E8362BH85-06A

S E R V I C E N O T E

E8362BH85 PNA Series RF Network Analyzers

Add-on mechanical components to enhance instrument reliability.

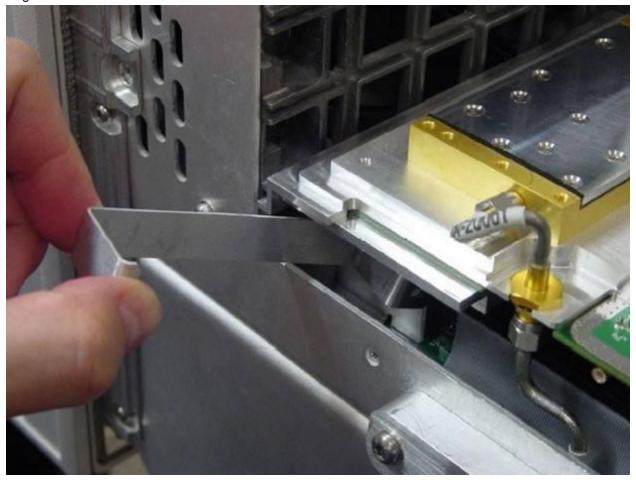
b. Insert Ribbon Cable Clamp under Source Assembly as shown.

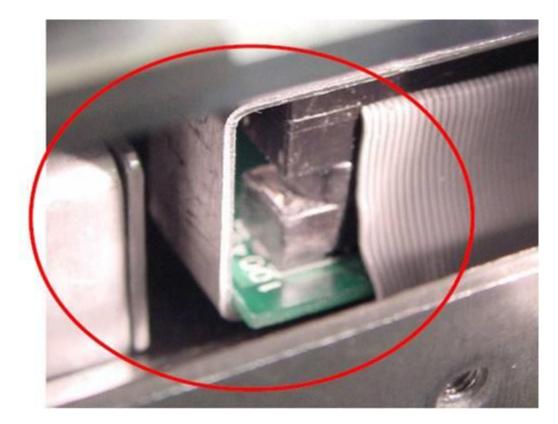
c. Position the clamp over the Ribbon Connector. Use needle nose pliers if necessary to slide the clamp into place. Ensure that the edge of the clamp is parallel to the connector and not skewed.

NOTE: Ensure that the Clamp Lip is secured BELOW the edge of the System Motherboard

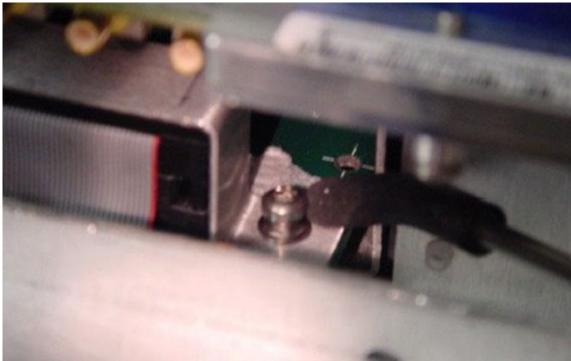
d. Using tweezers, install a new 0515-0374 screw through the hole in the bracket.

e. Use a nut runner tool (T-316130) or alternatively a clean erasure end of a pencil to help run the screw.

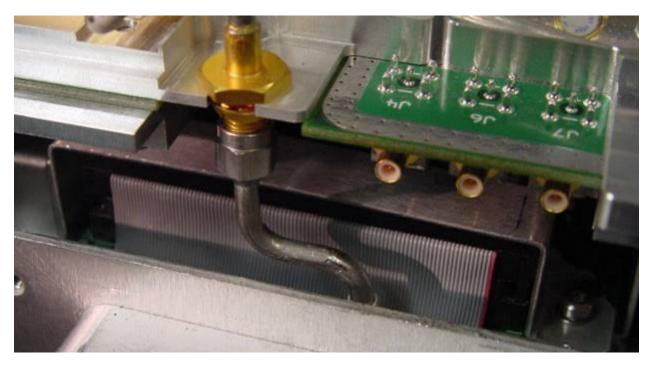
g. This image shows the final position of the secured clamp.

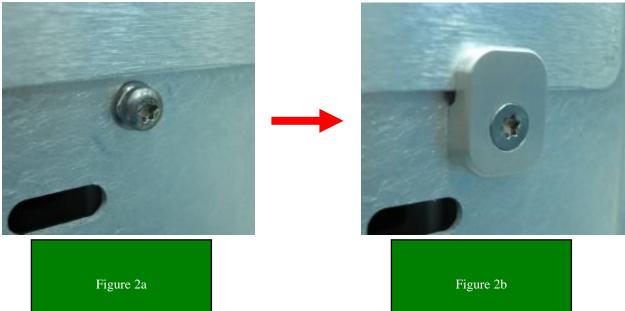
The Clip Retainer (E8361-20067) to be secured with Flat Head screw (0515-1644) in 2 places at 9 lb-in. This Retainer Clip may naturally rotate a bit when being secured, which is acceptable. Note that the existing screw needs to be removed and discarded prior installing Retainer Clip #1 (shown below in Figure 2a, 2b, and 3).

Figure 1:
Patch-Lock Screw (0515-2799)
And
Flat Washer (3050-0891)

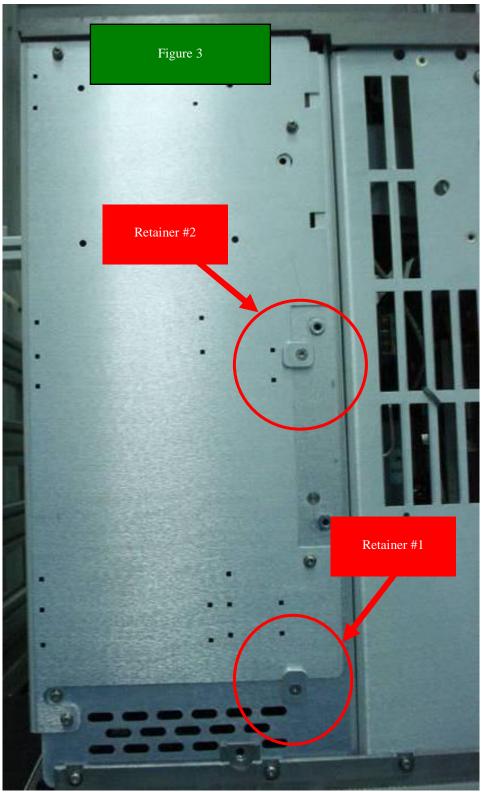
The Patch-Lock Screw (0515-2799) and Flat Washer (3050-0891) to be used in 2 places and secured at 9 lb-in. These parts will replace existing screw (0515-0374) used in Step 3 and Step 4 (as shown in Figure 2) to secure the Phase Lock Board (E8364-60137).
